**Application of Mustaq Moosa to rezone properties from R-100 (Residential-Medium Lot-100) District to C-1 (Local Commercial) District to construct a convenience store with accessory fuel pumps and alcohol outlet, at 1762 Panola Road.**

**PETITION NO:** N15. Z-21-1244544 2021-2122

### **STAFF ANALYSIS**

**Case No.:** Z-21-1244544 **Agenda #:** N. 15

# CONCEPTUAL SITE PLAN

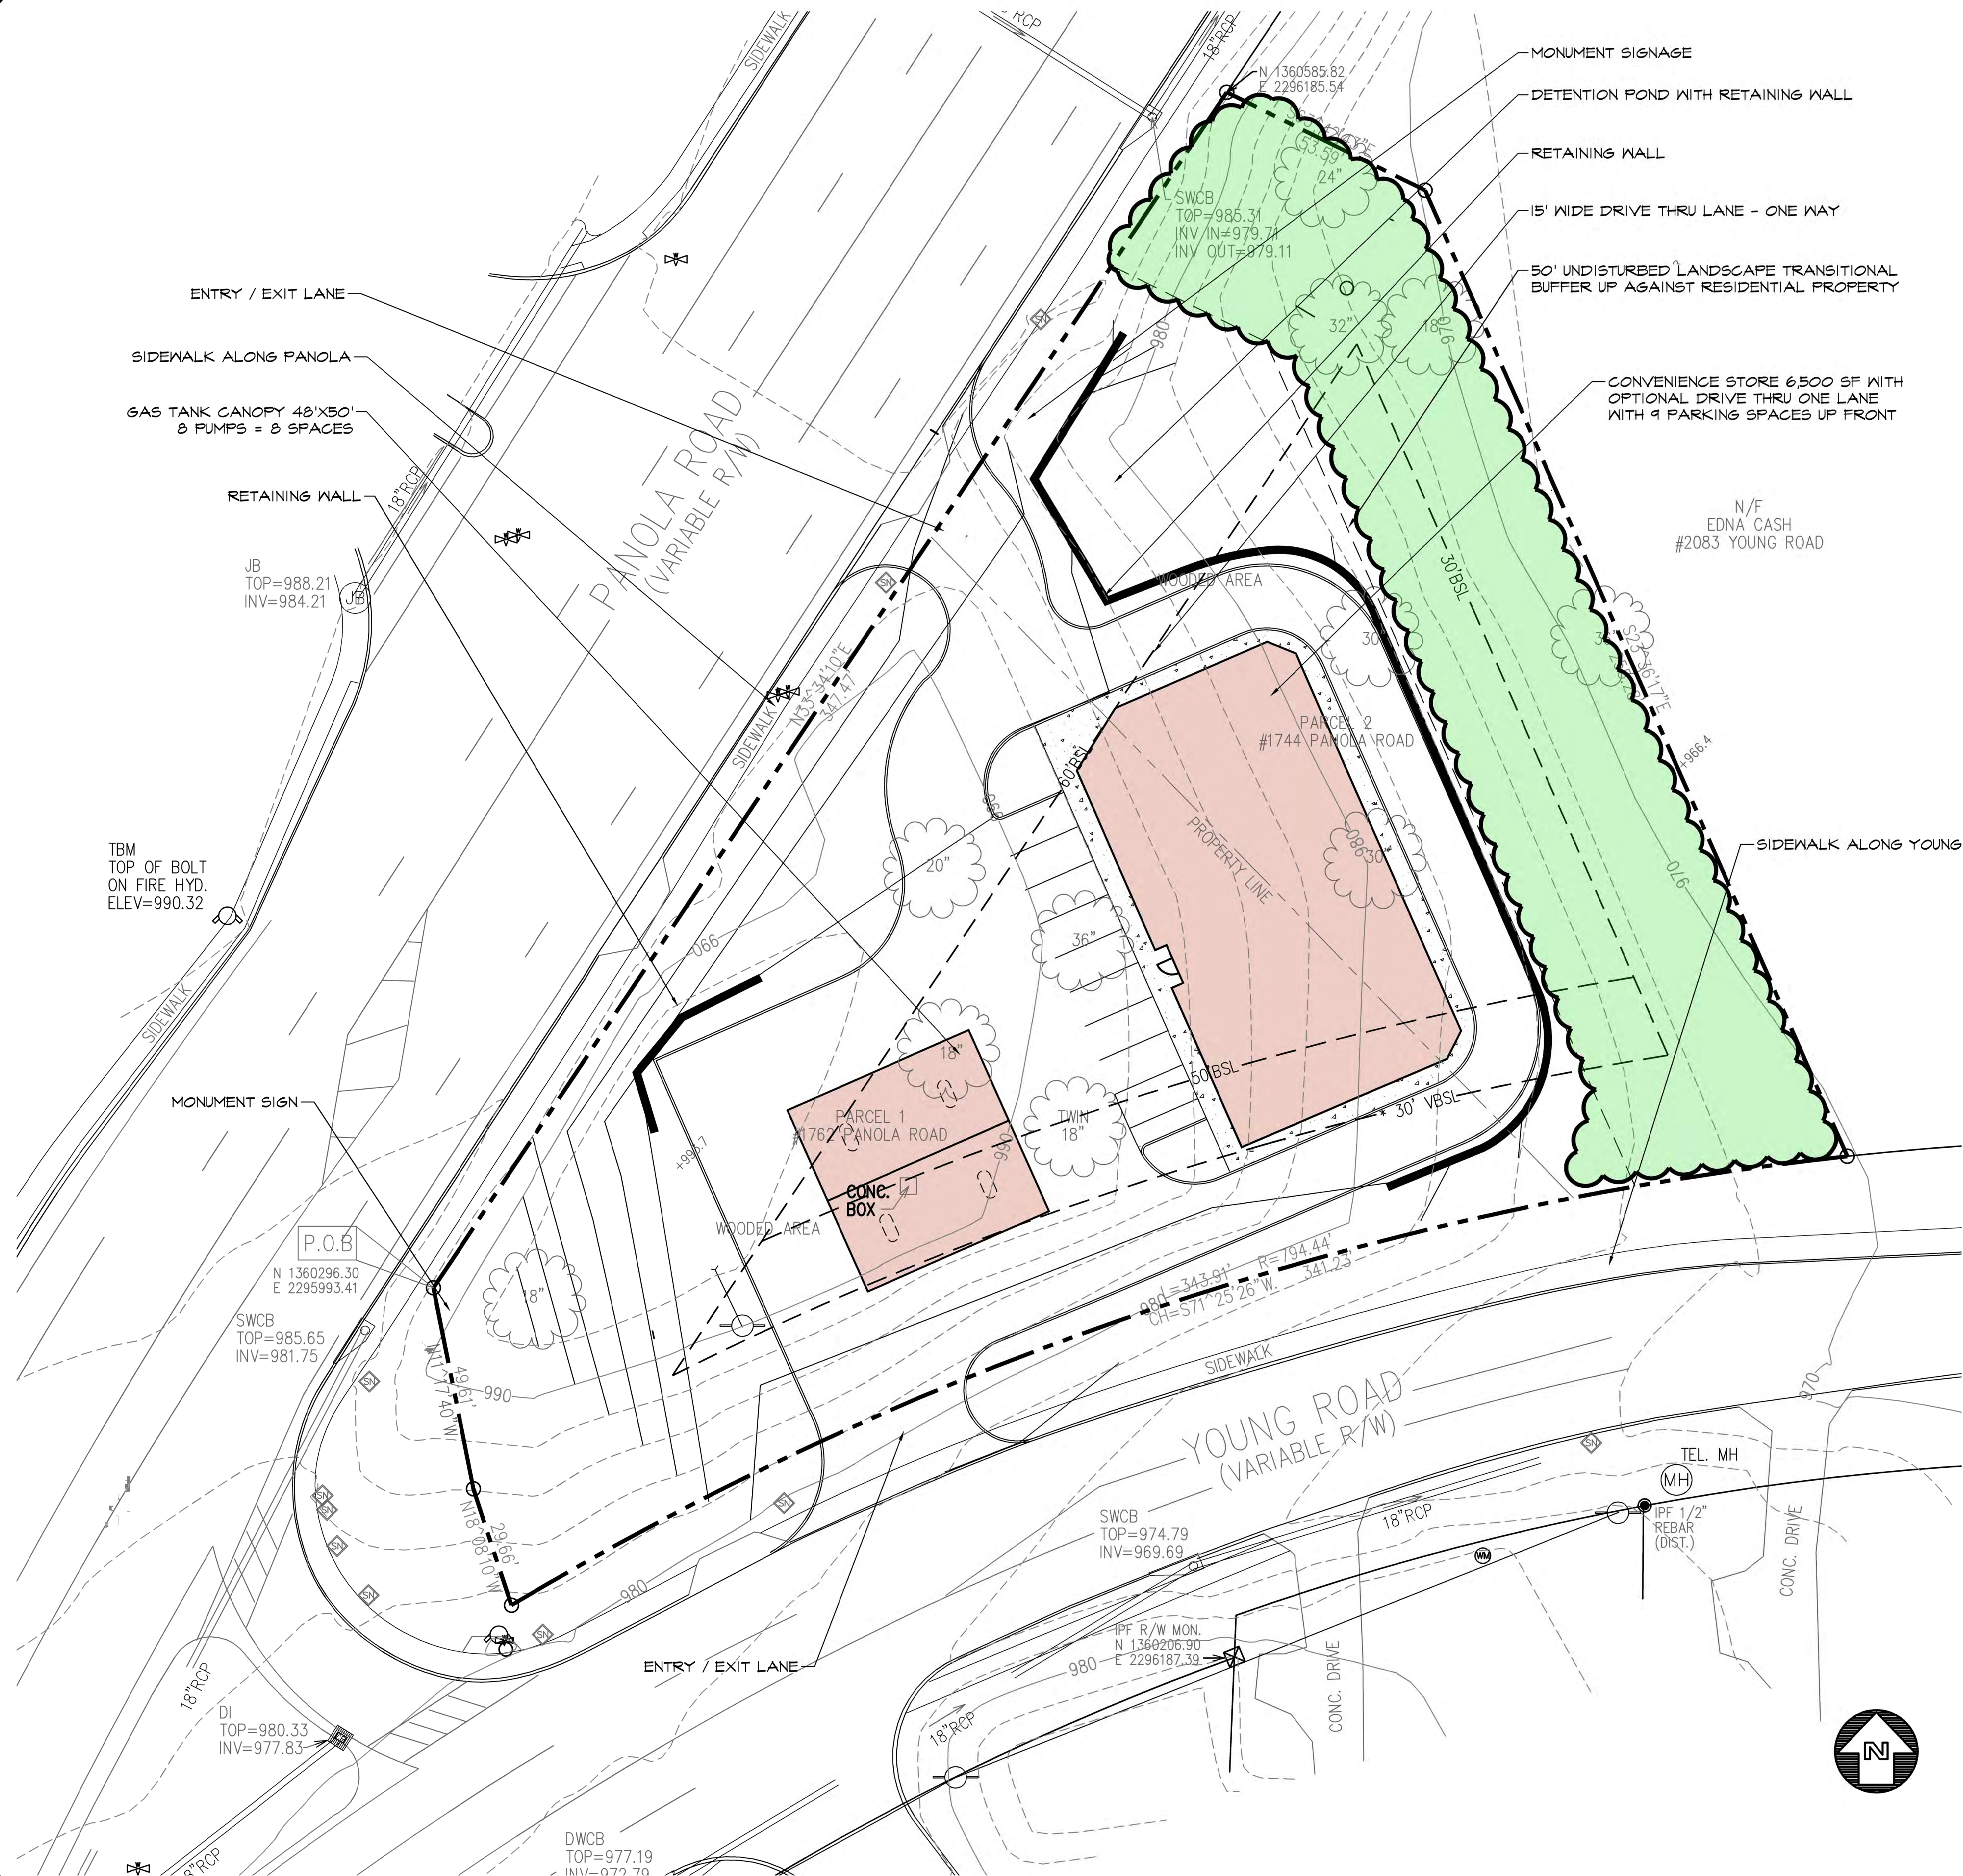
The site plan shows a retaining wall to be constructed along the north and eastern portion of the site, but the height of that retaining wall is not indicated. Retaining walls are limited to ten feet in height, unless a variance is obtained by the Board of Zoning Appeals. The site plan also shows an access drive around and behind the proposed building to facilitate safe and convenient ingress and egress within the site. The site plan does not indicate if this access drive will be used as a drive-through lane for a drive-through restaurant in the future. If a drive-through restaurant is proposed in the future, a Special Land Use Permit (SLUP) application shall be required to be submitted and approved by the Board of Commissioners.

The subject site has approximately 304 feet of frontage along Young Road and 347 feet of frontage along Panola Road. There is one proposed curb cut off Panola Road and one proposed curb cut off Young Road. Panola Road is a four-lane major arterial road with a center turn lane, curb and gutter, and no sidewalks. Young Road is a two-lane minor collector road with a center turn lane, curb and gutter, and no sidewalks. The proposed site plan is providing 5-foot wide sidewalks along Panola Road and Young Road. The DeKalb County Transportation Division of Public Works has indicated that the access point on Young Road needs to be relocated away from the traffic signal, and that the developer is required to upgrade the pedestrian features of the traffic signal at Panola Road at Young Road, as identified by the Transportation Division of Public Works. Additionally, a pedestrian connection must be provided from the public sidewalk to the building entrances.

Since a building setback variance is requested off of Young Road, approval cannot be based on the submitted concept plan. Approval of this rezoning application by the Board of Commissioners has no bearing on other approvals by the Zoning Board of Appeals or other authority, whose decision should be based on the merits of the application before said authority. The Department of Planning and Sustainability recommends "Approval" with the following conditions:

1. Not based on submitted site plan. Allow up to a 6,500 square foot convenience store and retail uses in conjunction with accessory fuel pumps and alcohol outlet.
